The City of Spartanburg Design Review Board

AGENDA

SUBJECT:
249 E. Main Street

DATE: April 2, 2024

SITE + BUILDING FOOTPRINT @ 1/32" = 1'-0"

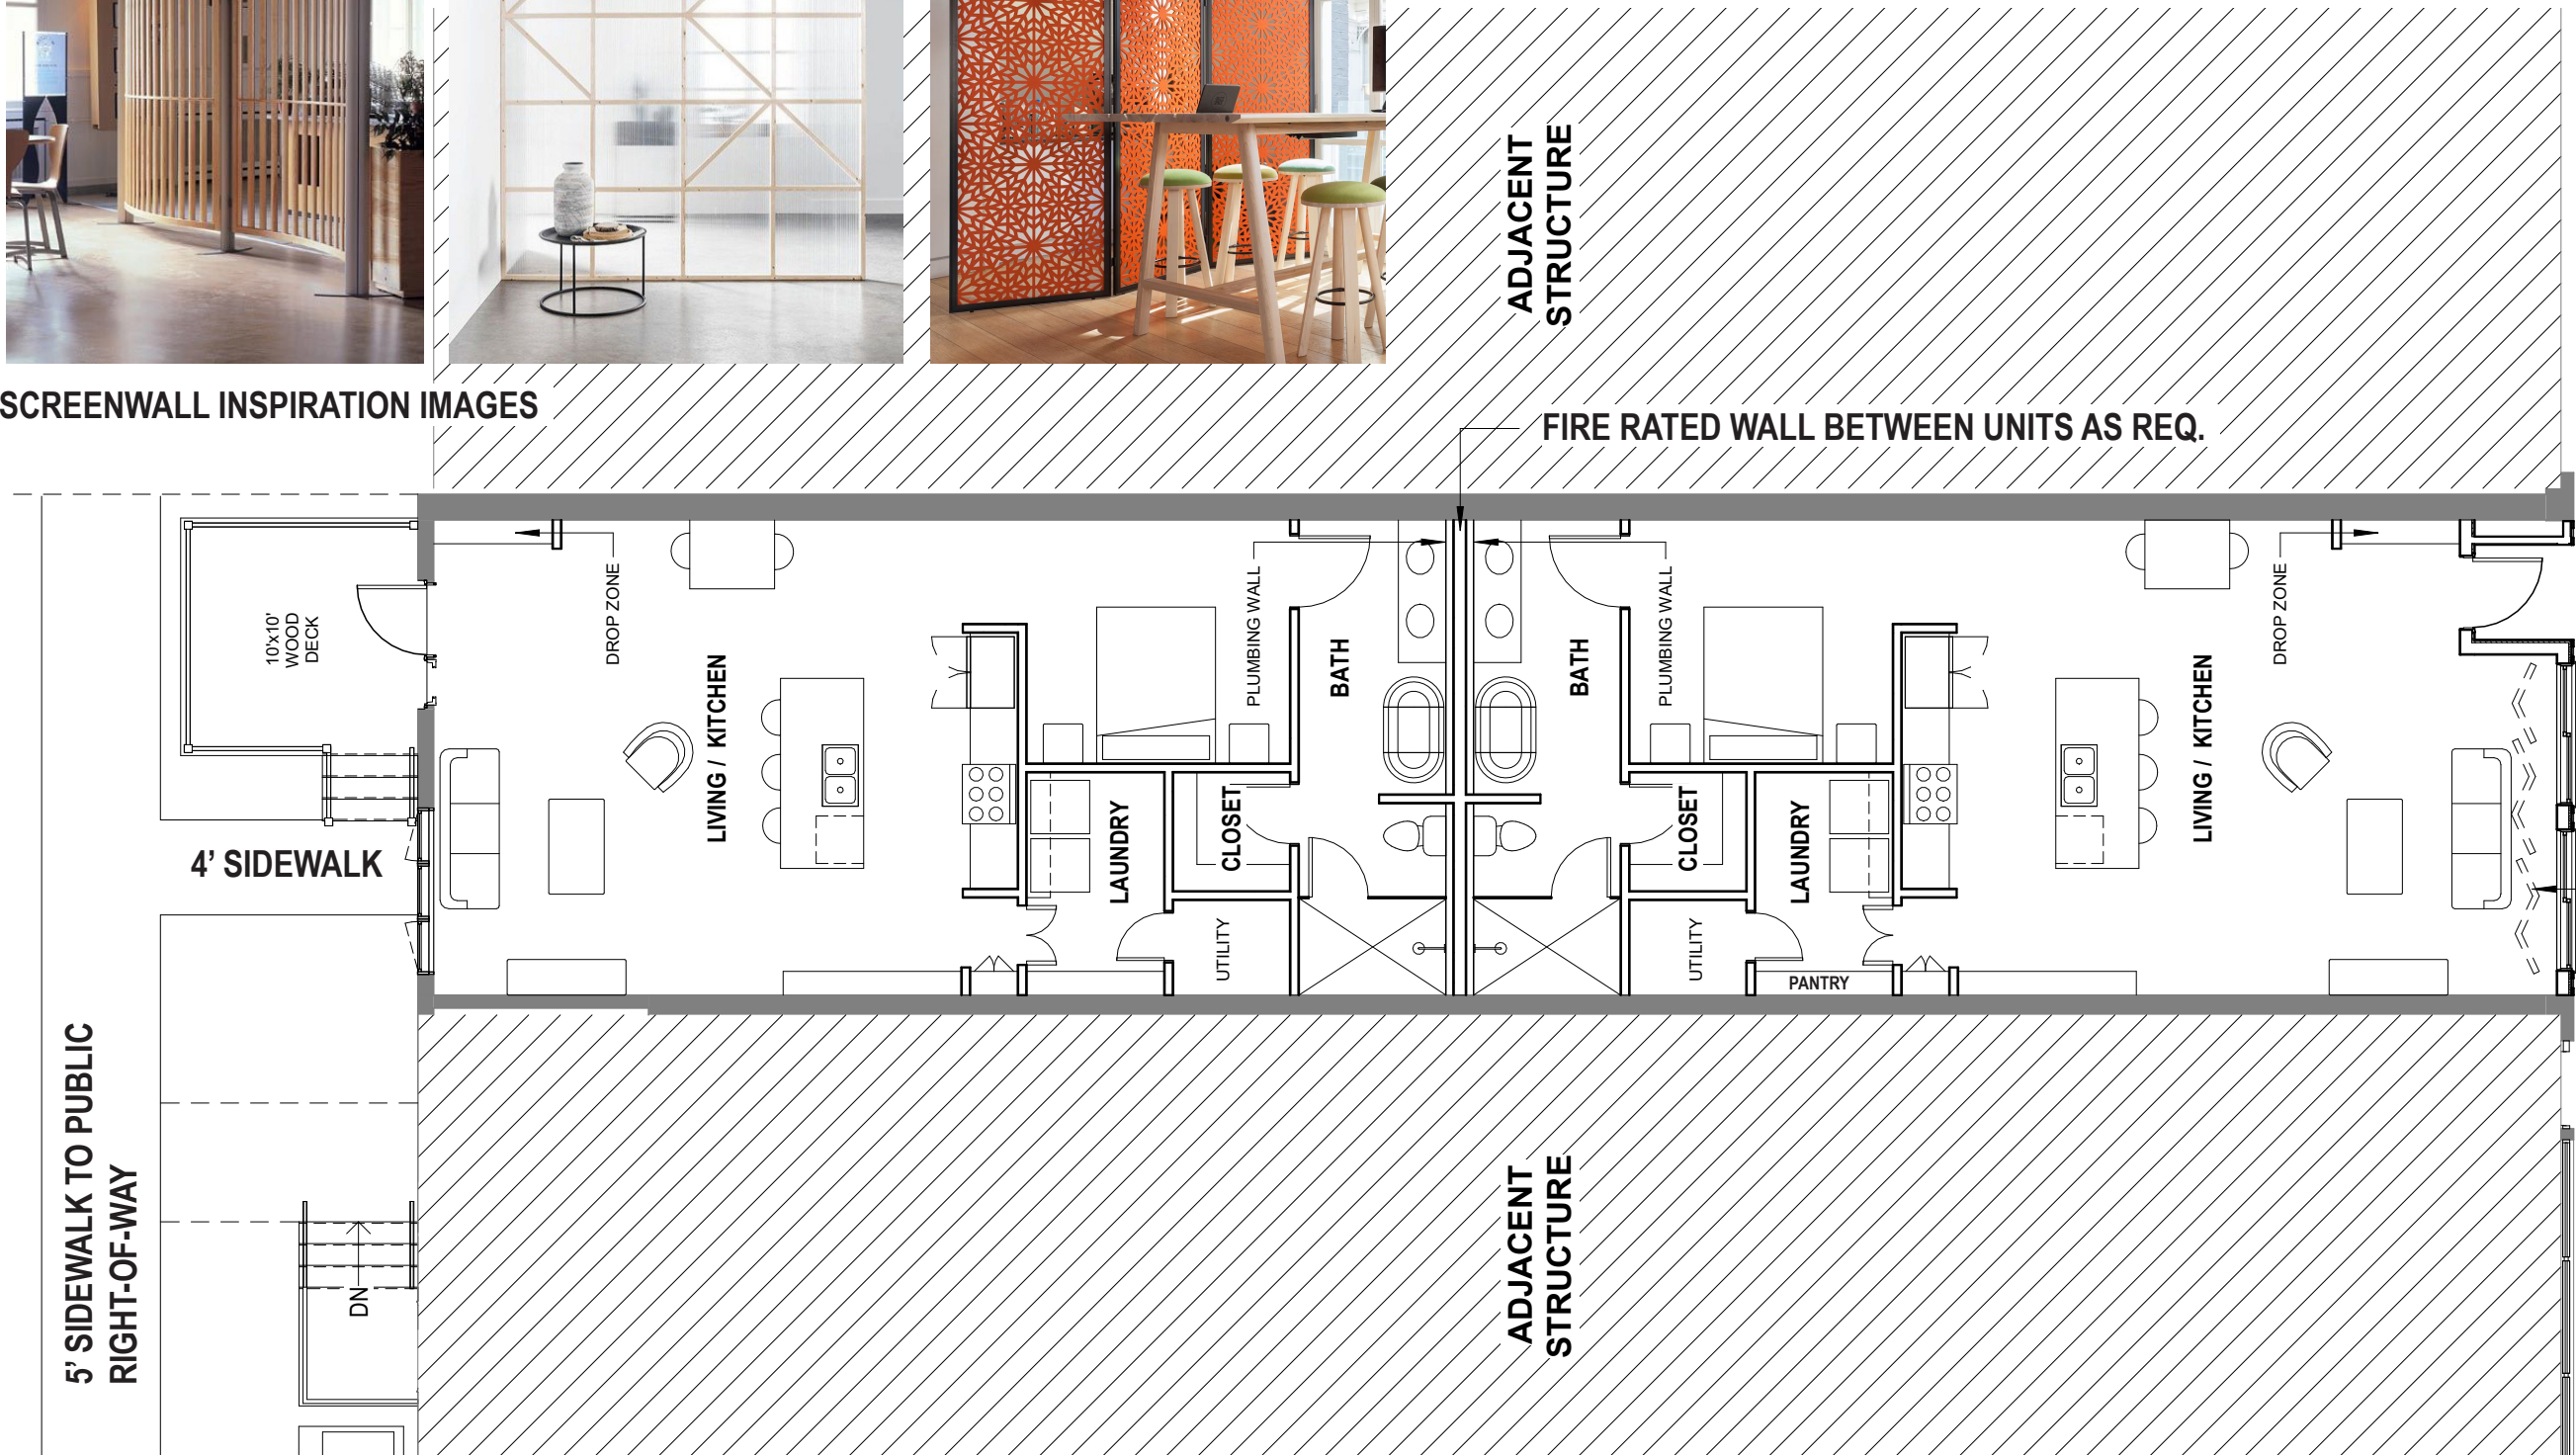
- **Front Unit Entry:** The proposed front façade is consistent with the neighboring commercial properties though we continue to question the direct access entry from the sidewalk into the living space of the unit. The code requires that residential units be elevated to provide a sense of privacy from the sidewalk but no alternate configuration has been provided. We would strongly encourage some type of visual offset or an entry vestibule to provide a more appropriate transition to the private space.

- **Front Façade Canopy/Awning:** The proposed recessed is proposed in lieu of the provision of building canopy/awning as required by the building typology. The purpose of this requirement along a main street is two-fold: to provide shelter prior to entry and to provide shelter to pedestrian walking by. The grant of an exception is predicated upon a change necessitated by a site-specific condition, building-specific condition or an innovative manner in which to fulfill the overall design intent of this Code. We do not believe that the application shows a building-specific need to eliminate this requirement nor do we think that it shows an innovative manner in which to fulfill the design intent.

- **Privacy Screening:** The applicants have suggested that the individual residents can use a flexible interior screen as a means to provide natural light while keeping curtains or blinds open to avoid a blank wall condition. We do not think that this solution will provide enough privacy to the unit to preclude this condition. Blank walls and dead spaces simply do not encourage pedestrian activity. Great Main Streets have a continuity of active, ground floor spaces that cast light onto the sidewalk at night and provide visual diversity to a pedestrian. The lack of these ingredients causes a well-documented emotional response that is equivalent to stress or fear which discourages pedestrian activity. As well-intentioned as an interior screen may be, we do not think that it is sufficient to permanently meet the intent of the code.

LANDSCAPE PLAN

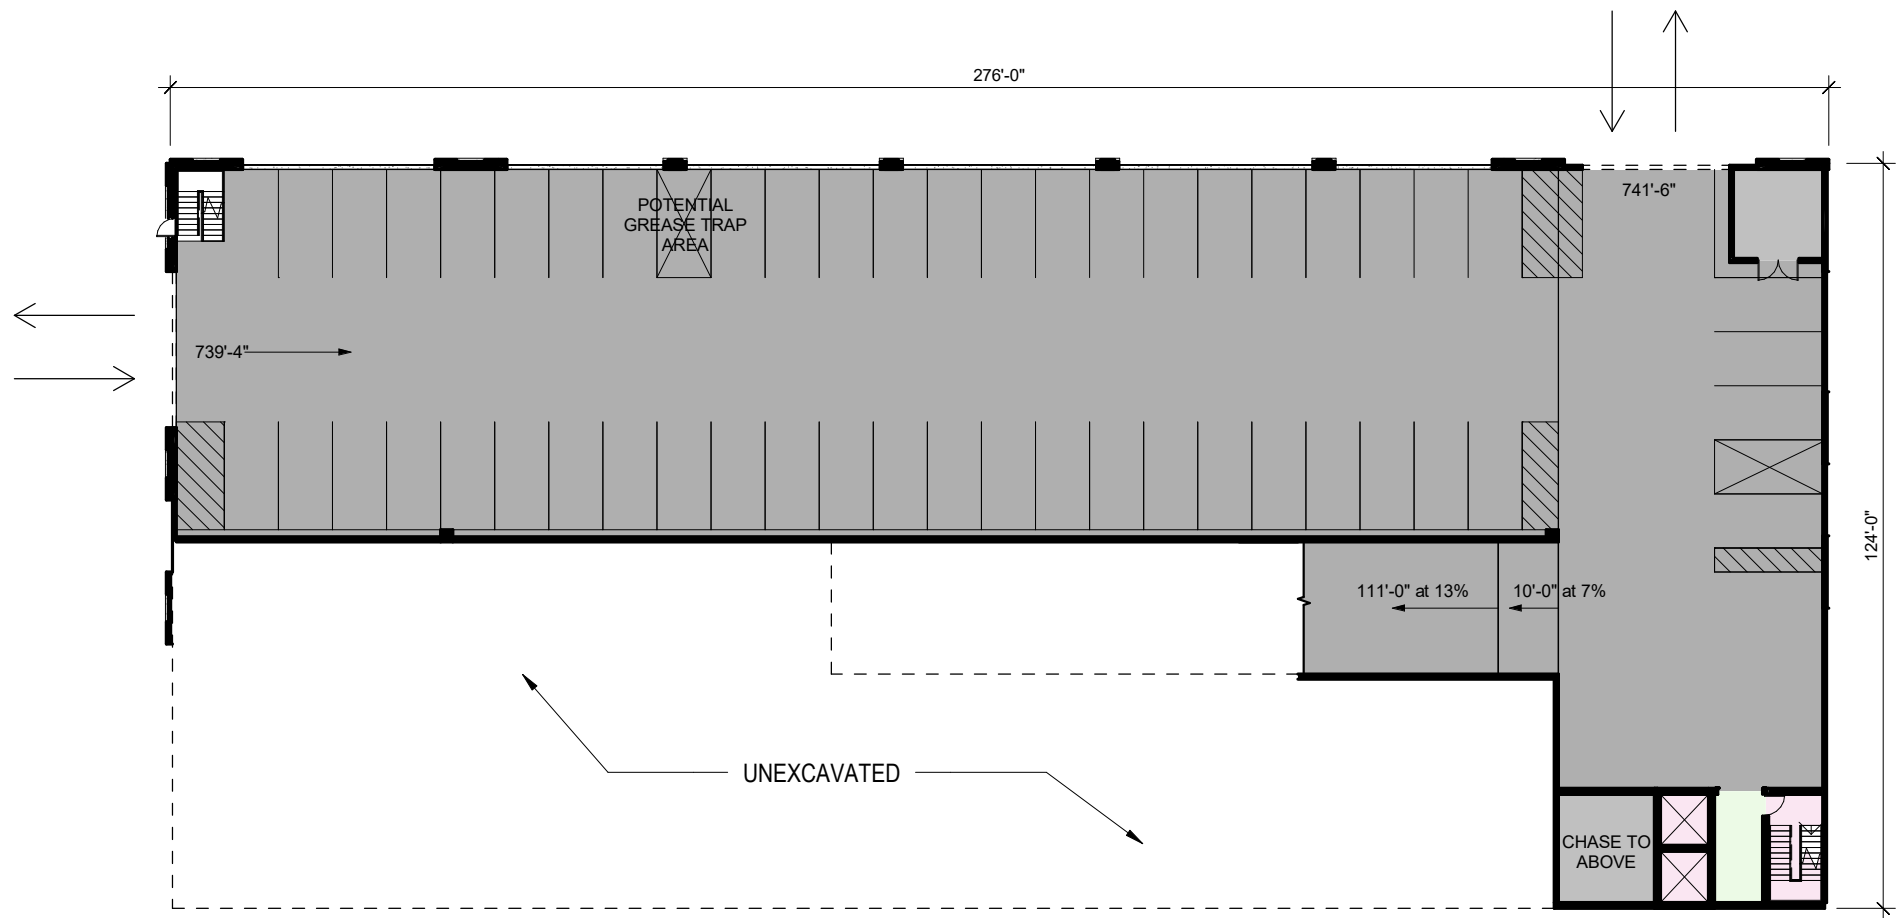
- **Substandard Streetscape across frontage of parking lot and parking garage:** The proposed sidewalk zone along the western side (along access drive) of this site is a 4.5 ft planting strip and a 5 ft sidewalk directly adjacent to the building. The code requires a 12 foot zone with an 8 ft sidewalk zone and trees planted in wells. The sidewalk along the ballpark edge to the immediate south is an 8 ft planting strip, 6 ft sidewalk and a 2.5 ft foundation planting which would ideally be continued along the garage. We understand this sidewalk is not intended to be a primary pedestrian route (the plaza on the east side of the garage, currently under design, is intended to be the primary pedestrian route to the stadium).

Section 515.8 Table indicates that streetscape in the DT-5 shall have a 12-foot street scape zone. We are requesting a discretionary approval for a 9.5' streetscape zone along the future access road for the following reasons: the nature of the site location, the access road along the CSX rail corridor, the difference in grade between the plaza level and the ground level access, the dimensional requirements of a functional garage, the coordination with adjacent structures, and the location of underground storm water structures associated with future development. Otherwise, this project is fully code compliant.
